UNITED STATES PATENT AND TRADEMARK OFFICE

APPLICATION NO.	FILING DATE	FIRST NAMED INVENTOR	ATTORNEY DOCKET NO.	CONFIRMATION NO.
10/526,452	03/02/2005	Andreas Zahnd	71190	3135
23872	7590	03/27/2006	EXAMINER	
MCGLEW & TUTTLE, PC P.O. BOX 9227 SCARBOROUGH STATION SCARBOROUGH, NY 10510-9227			EVANISKO, LESLIE J	
			ART UNIT	PAPER NUMBER
			2854

Office Action Summary	Application No.	Applicant(s)	
	10/526,452	ZAHND ET AL.	
	Examiner	Art Unit	
	Leslie J. Evanisko	2854

DETAILED ACTION

3,362,327

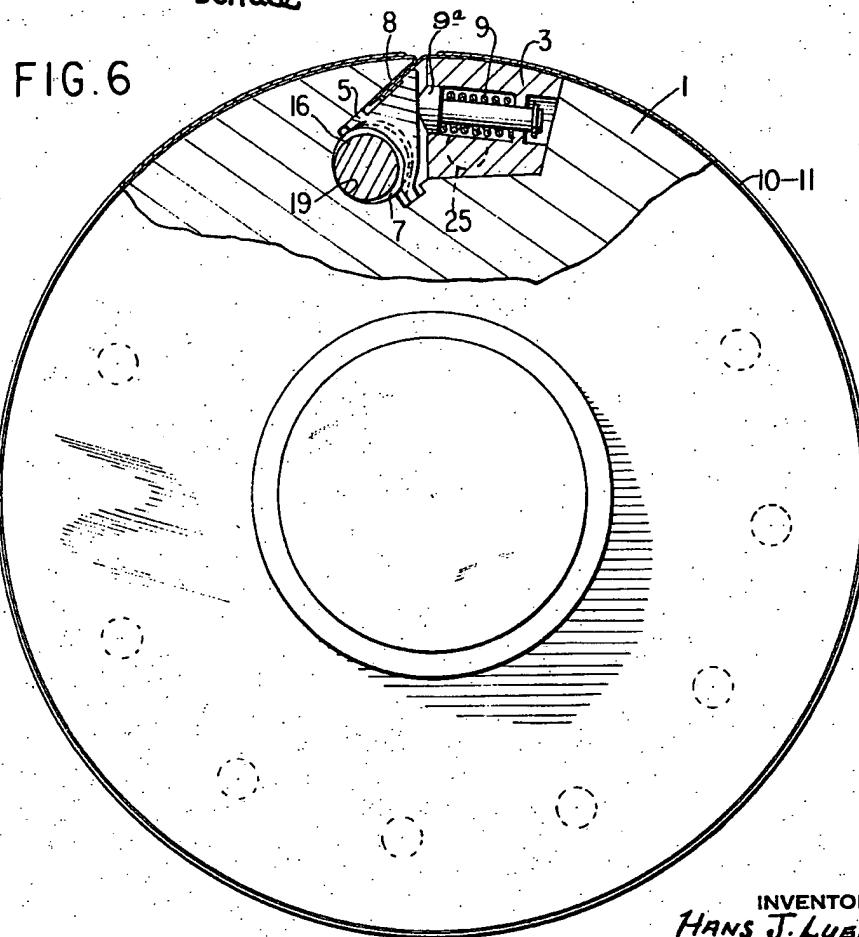
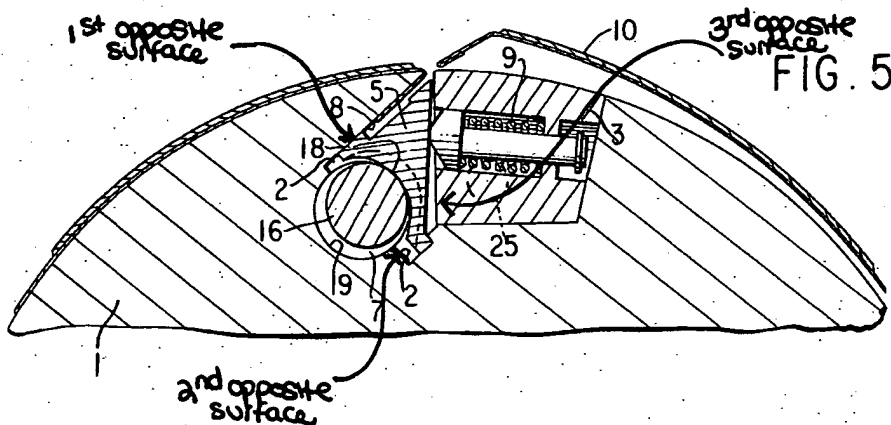
the axial channel 2; two channel walls (as illustrated in marked-up copy of Figure 5 attached to this Office Action) which face the first opposite surface, and which form the second opposite surface and third opposite surface, on which the clamping body 4, 5, 6, 7 is supported, touching the opposite surfaces; wherein at least one of the clamping body 4, 5, 6, 7 and opposite surfaces form a spring and the force of elasticity of the spring tensions the clamping body and the first opposite surface towards each other in order to clamp the at least one end of the packing 10, 11 with the packing pulled in. See, in particular, Figures 1b and 3-6 and the marked-up copy of Figure 5 attached to this Office Action.

With respect to claim 2, note the opposite surfaces of Luehrs are formed both on the cylinder 1 and a filler 3 immovably bound in the cylinder 1.

With respect to claim 3, note the opposite surfaces of Luehrs form support points for the clamping body which are distributed around the circumference of the clamping body, wherein two adjacent support points each have an angular distance of less than 180°, as shown in Figures 5 and 6 in particular.

With respect to claims 15-16, note Luehrs teaches an insert 9a, 9 (i.e., springs) inserted into a channel wall limiting the channel 2 forms the spring, as described in column 2, lines 23-30. Note this insert is a spring member, and spring members would inherently be comprised of elastic material to some extent.

2,900,904

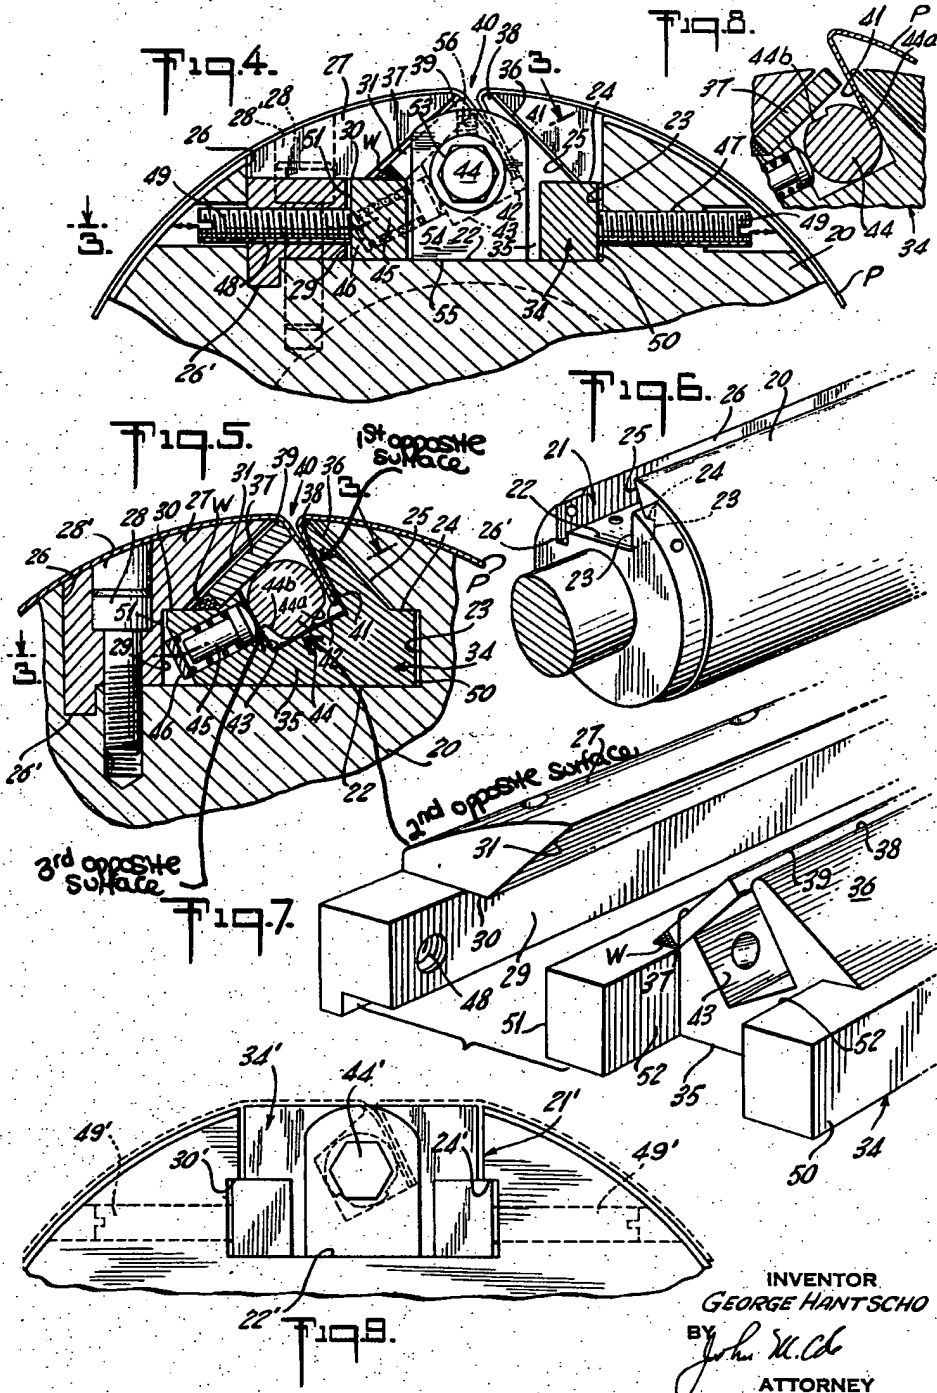
9. Claims 1-3, 15-16, 20, and 27 are rejected under 35 U.S.C. 102(b) as being anticipated by Hantscho (US 2,900,904). Hantscho teaches a clamping device for clamping a flexible packing P of a cylinder 20 of a printing press, which cylinder has an axial channel 43 on a jacket surface, the clamping device comprising a clamping body 44 which forms a clamping gap in the axial channel with a first opposite surface (face defined by edge 38) for at least one end 41, 42 of the packing P, which end protrudes through the opening 40 of the axial channel 43; two channel walls (as illustrated in marked-up copy of Figure 5 attached to this Office Action) which face the first opposite surface, and which form the second opposite surface and third opposite surface, on which the clamping body 44 is supported, touching the opposite surfaces; wherein at least one of the clamping body 44 and opposite surfaces form a spring and the force of elasticity of the spring tensions the clamping body and the first opposite surface towards each other in order to clamp the at least one end 41, 42 of the packing P with the packing pulled in. See, in particular, Figures 4-8 and the marked-up copy of Figure 5 attached to this Office Action.

With respect to claim 2, note the opposite surfaces of Hantscho are formed on a filler 34 immovably bound in the cylinder 20.

With respect to claim 3, note the opposite surfaces of Hantscho form support points for the clamping body which are distributed around the circumference of the clamping body, wherein two adjacent support points each have an angular distance of less than 180°, as shown in Figures 5 and 8 in particular.

With respect to claims 15-16, note Hantscho teaches an insert 45 (i.e., spring plungers) inserted into a channel wall limiting the channel 43 forms the spring, as described in column 2, lines 64-65. Note this insert is a spring member, and spring members would inherently be comprised of elastic material to some extent.

With respect to claim 20, note Hantscho teaches a recess 21 which is formed on the jacket surface of the cylinder and at least one filler 34 inserted into the recess form the channel 43 and limiting edges 38, 39 of the opening 40 of the channel 43, the filler 34 being provided with an insert 45 that is elastic in its material.
